## Rutland County Council

Application:	<b>2020/0435/FUL</b>	<b>ITEM 2</b>	
Proposal:	<b>Erection of canopy over front door of property.</b>		
Address:	<b>85 Main Street, Greetham, Rutland, LE15 7NJ</b>		
Applicant:	<b>Mr Richard Brett</b>	Parish	<b>Greetham</b>
Agent:	<b>N/A</b>	Ward	<b>Greetham</b>
Reason for presenting to Committee:	<b>Relation to RCC Employee</b>		
Date of Committee:	<b>28<sup>th</sup> July 2020</b>

Canopy porch  
85 Main Street  
Greetham,  
For Mr & Mrs Brett  
Plans & Elevations

876/20/1B

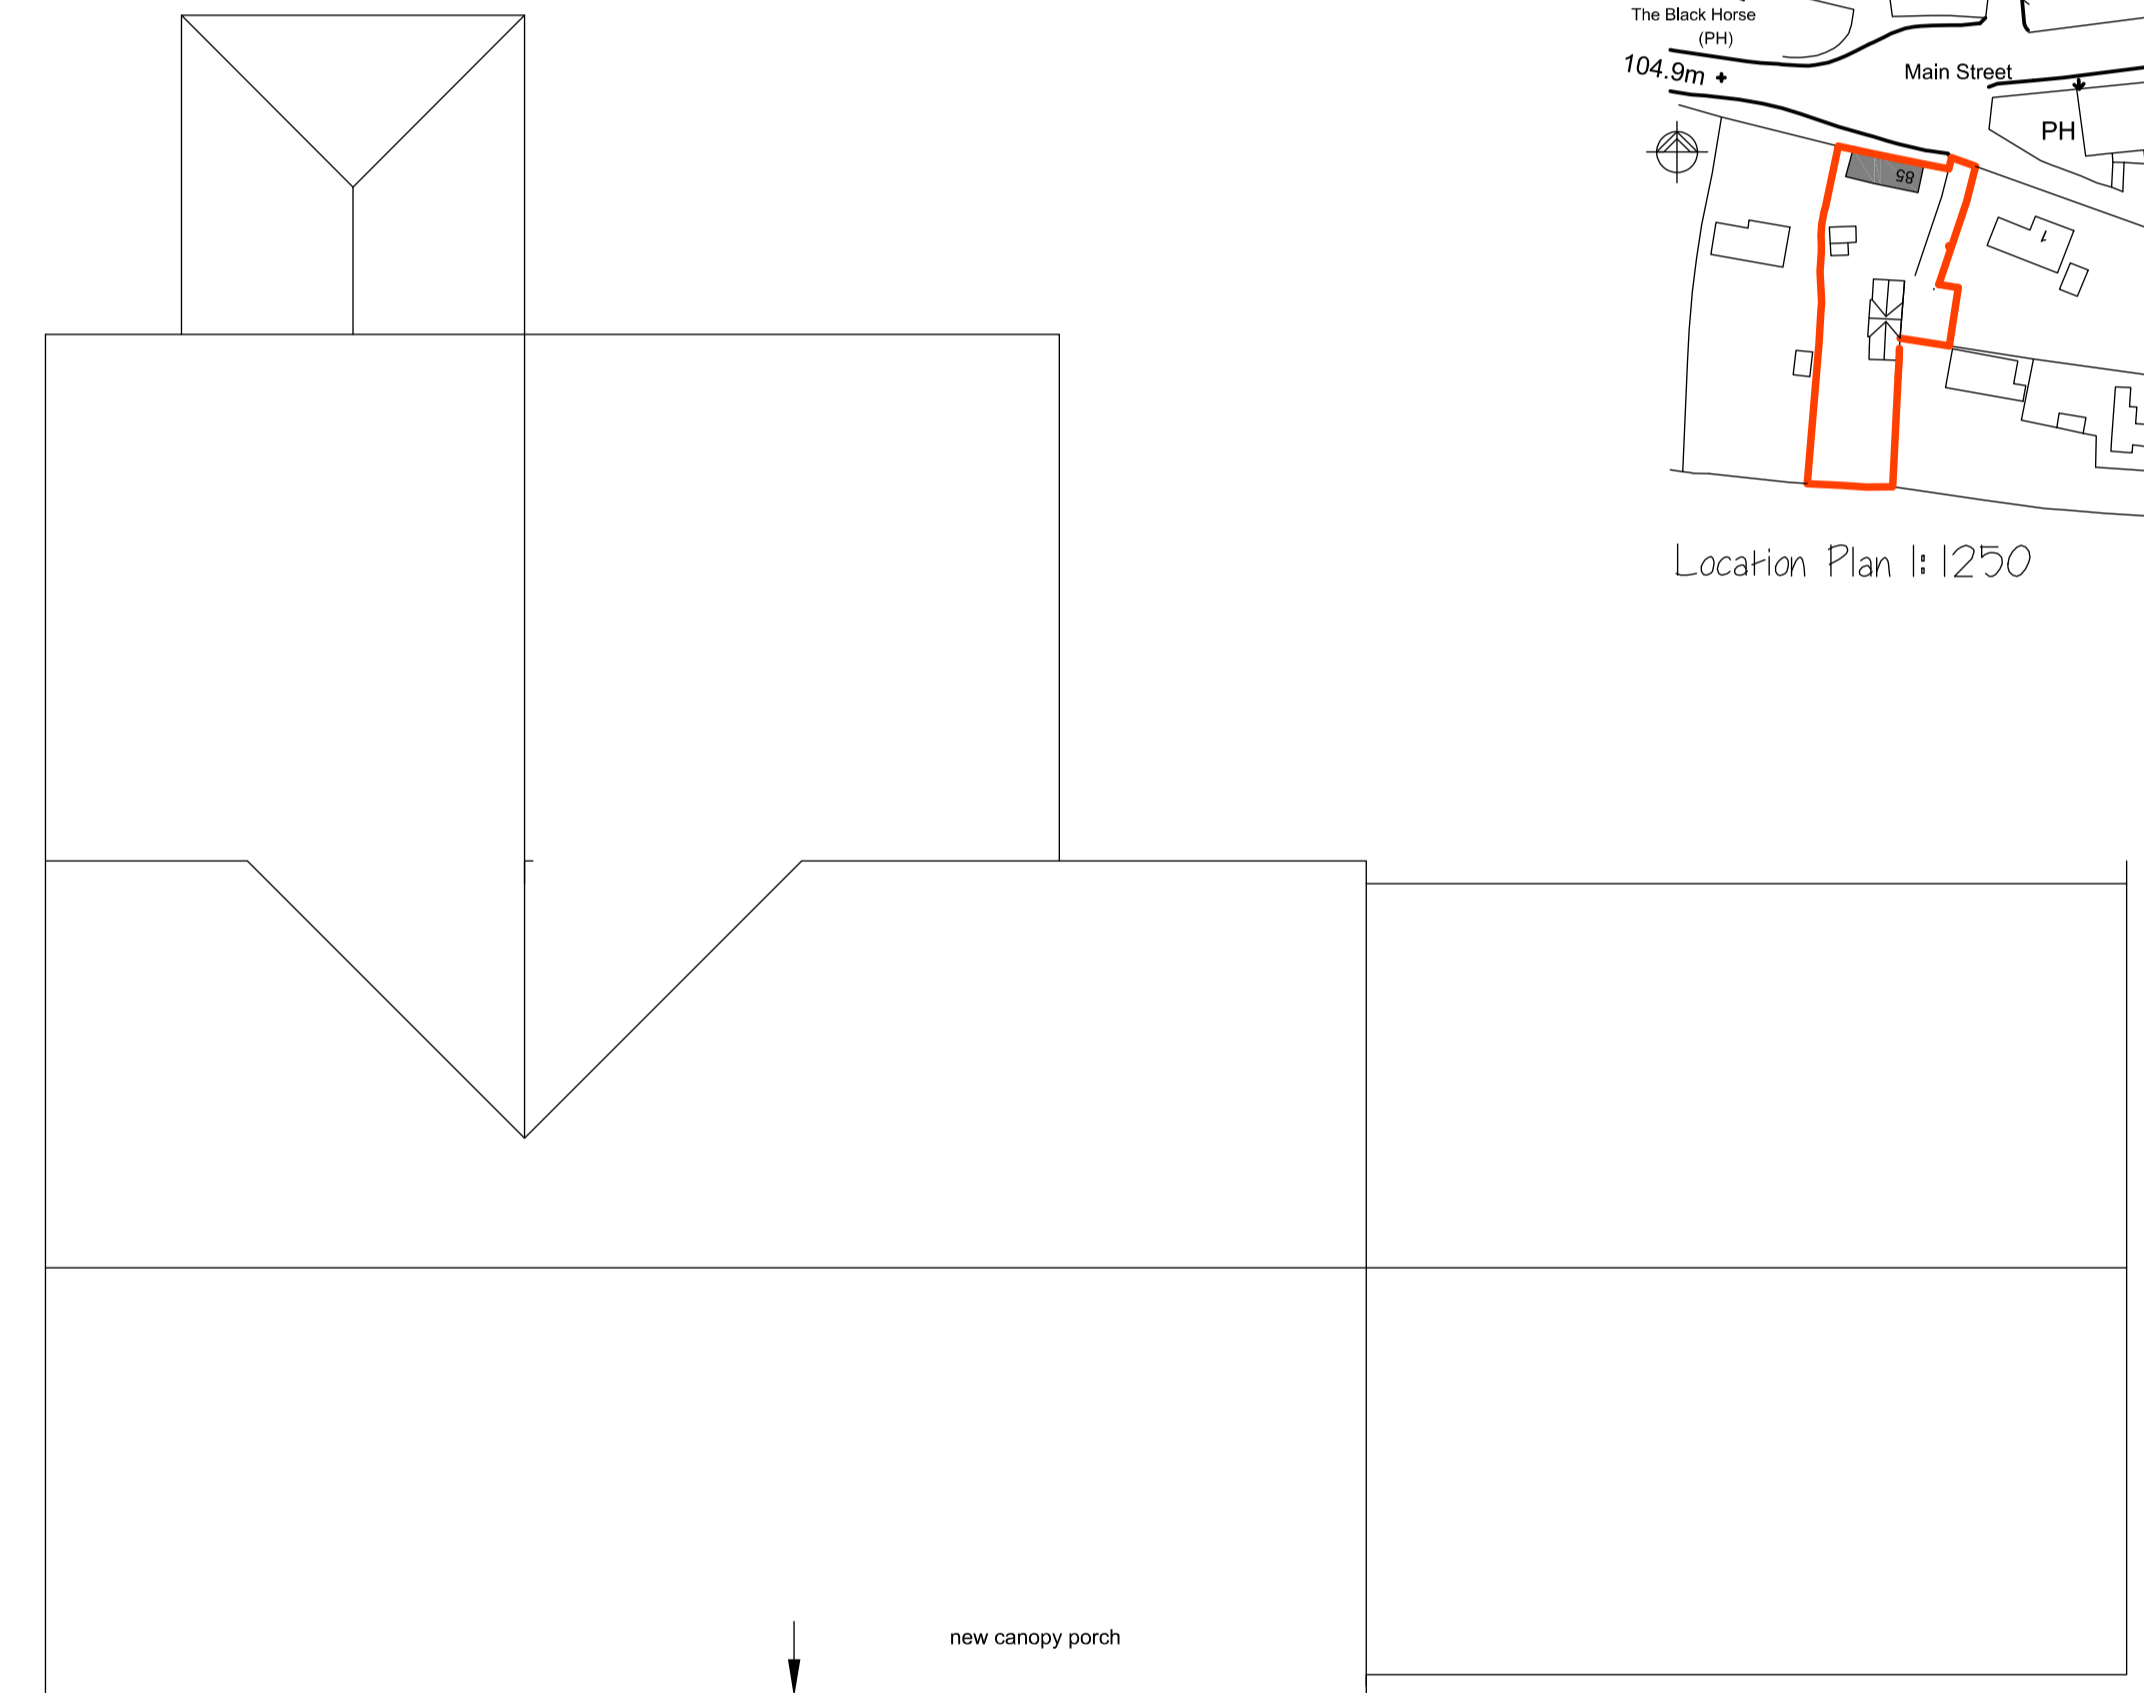
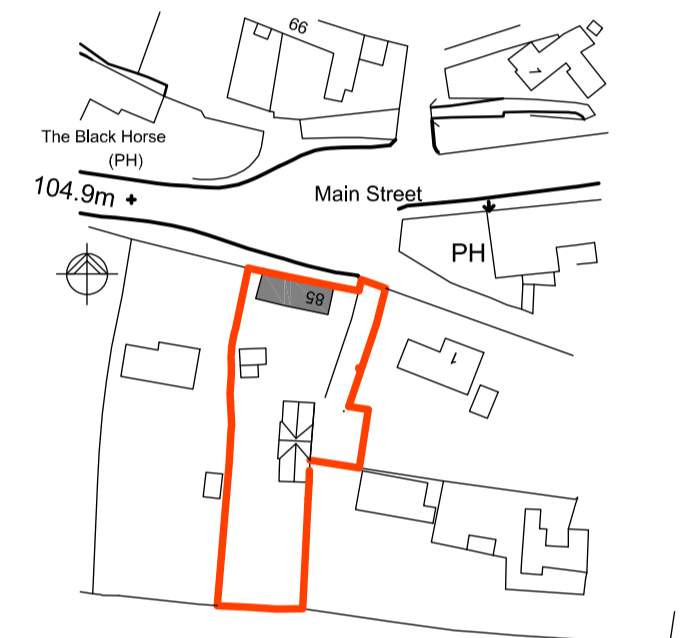
6. **Conservation Advisor**  
Whilst I can see no objection to the installation of a canopy I question the appropriateness of the hipped roof design in this instance and suggest therefore that design be reconsidered with a view to the roof having either an apex or pent roof rather than the somewhat incongruous hipped as currently proposed.

11. The application originally proposed a hipped roof canopy porch. Following concerns from the Conservation Officer on the design of the hipped roof being an incongruous feature, the plans were revised to a mono-pitched (pent) roof. While there has previously been a

(Following submission of revised plans showing mono-pitched porch) – No objection.

Revision B: canopy roof amended  
© McCombie Smith Architects
